SUBJECT: Savannah River Site's Responses to the Regulatory Comments on the 2023 K-Area Burning/Rubble Pit and Rubble Pile (131-K and 631-20G) (KBRP) and P-Area Burning/Rubble Pit (131-P) (PBRP) Operable Units Combined Groundwater Monitoring Report (Sampling Summary), SEMS Numbers: 40 and 59

SRS Responses to the U.S. Environmental Protection Agency's Comments on the 2023 K-Area Burning/Rubble Pit and Rubble Pile (131-K and 631-20G) (KBRP) and P-Area Burning/Rubble Pit (131-P) (PBRP) Operable Units Combined Groundwater Monitoring Report (Sampling Summary), SEMS Numbers: 40 and 59

2023 K-Area Burning/Rubble Pit and Rubble Pile (131-K and 631-20G) (KBRP) and P-Area Burning/Rubble Pit (131-P) (PBRP) Operable Units Combined Groundwater Monitoring Report (Sampling Summary), SEMS Numbers: 40 and 59, SRNS-J2000-2024-00462, Revision 0, Dated June 2024
Savannah River Site, Aiken, South Carolina

Figure CR-1. PBRP OU Synchronous Water Elevation Map

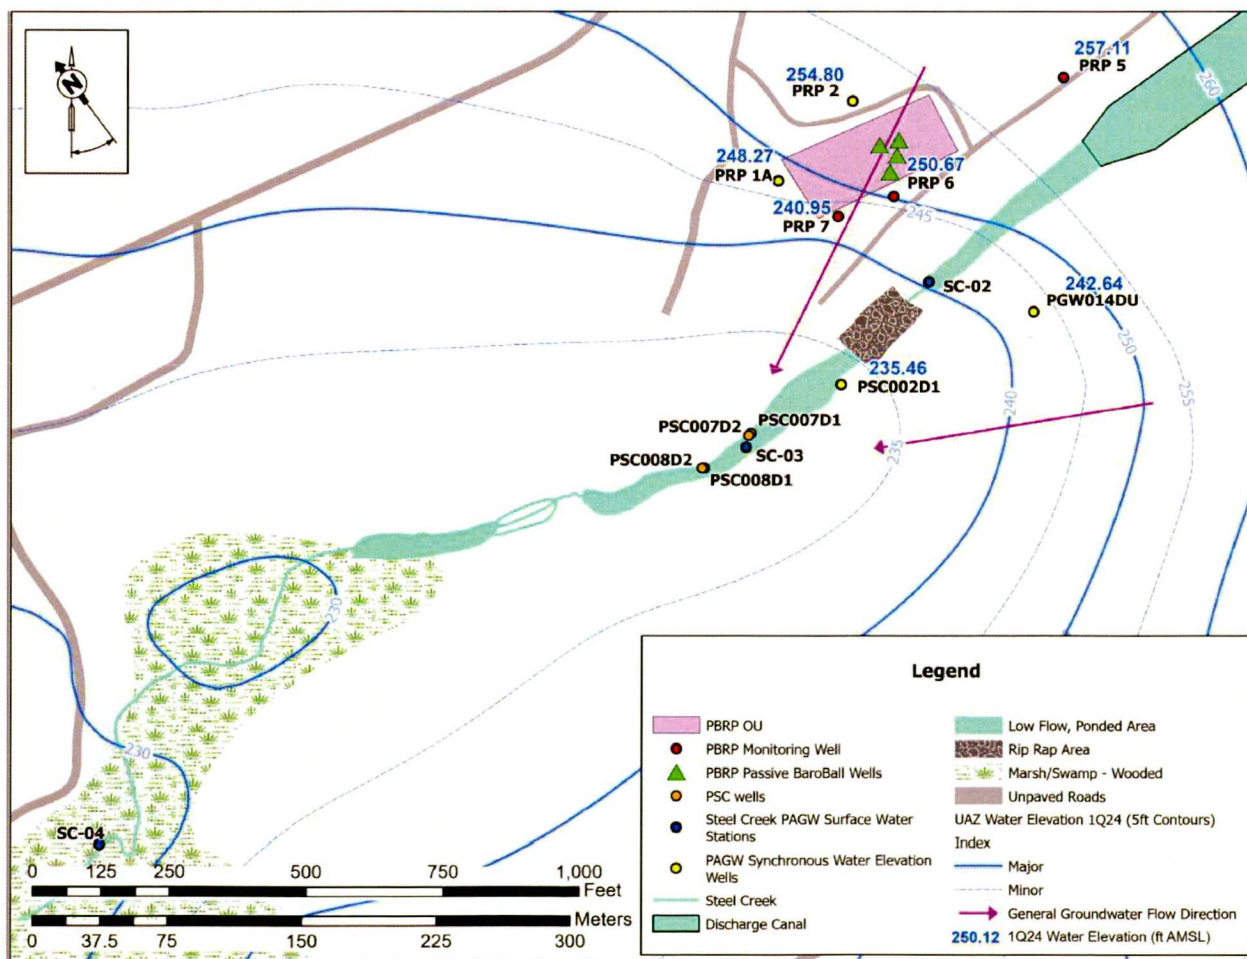
- I. The use of sample results from (SW) surface-water station SC-03 is not appropriate for evaluating potential of impacts to Steel Creek from the P-Area Burning/Rubble Pit (PBRP) Operable Unit (OU) trichloroethylene (TCE) plume due to groundwater to surface water discharge. According to the text on page 10, the TCE detections in the P-Area Groundwater (PAGW) OU SW station SC-03 are attributed to the PAGW OU upper aquifer zone (UAZ) TCE plume. According to Figure 6 (TCE Contaminant Distribution), SW station SC-03 is located on the south side of Steel Creek and within the PAGW OU TCE plume; however, a more representative SW sample station located north of and slightly upstream of Steel Creek would be more appropriate for detecting potential impacts to Steel Creek from the PBRP OU. The GW Monitoring Report states that surface water sampling will continue at the current locations to confirm that the recent elevated concentrations of volatile organic compounds (VOCs) have no impact within Steel Creek. As such, *please revise the text to recommend moving SW station SC-03 to the north side of Steel Creek and upstream of the PAGW TCE plume, during future sampling events.*

As stated in the regulatory approved *Savannah River Site's Responses to the Regulatory Comments on the K-Area Burning/Rubble Pit and Rubble Pile (131-K and 631-20G) (KBRP) and P-Area Burning/Rubble Pit (131-P) (PBRP) Operable Units Combined Groundwater Monitoring Report (SRNS-RP-2022-00253, Revision 0, June 2022) SEMS Numbers: 40 and 59 (IACD-23-121, dated January 19, 2023)*, surface-water sampling for 1,1-dichloroethylene, 1,4-dioxane and TCE was conducted at Steel Creek surface-water stations SC-02, SC-03, and SC-04 beginning in the first quarter of 2023. Groundwater contamination contributions from PAGW OU to Steel Creek are primarily TCE and tritium. 1,1-Dichloroethylene and 1,4-dioxane are not groundwater contaminants associated with the PAGW OU. Any detections of these contaminants would be associated with PBRP OU. Contributions of TCE contamination to Steel Creek can be further evaluated by assessing the data collected from shallow wells that are installed on both sides of Steel Creek. SRS believes the existing impact to surface water is associated with the PAGW OU.

The locations of the surface water stations were selected to observe the impacts of the PAGW plume; however, in an effort to observe the impact of VOCs from PBRP to Steel Creek, the results of the three surface water stations were also included in the PBRP report. Based on the potentiometric surface within the area, SC-03 is located in the flow path of groundwater discharge from the PBRP OU to Steel Creek, see Figure CR-1 below. A location located north and upstream would not capture the impacts from the PBRP OU to Steel Creek, as the location of the surface water station SC-03 is actually located centrally within the Steel Creek. This is because the SC-03 location is not accurately

depicted on the figures within the sampling summary. SRS will make corrections to future reports to accurately depict this location within Steel Creek as shown in Figure CR-1 below.

In 2024, four shallow monitoring wells were installed on the PBRP OU side of Steel Creek to observe any potential contaminant migration from the unit. The wells are in the vicinity of SC-03 along Steel Creek and located on the bank side to PBRP, see Figure CR-1 below. Data collected from these wells will be reported in the 2027 Groundwater Monitoring Report.
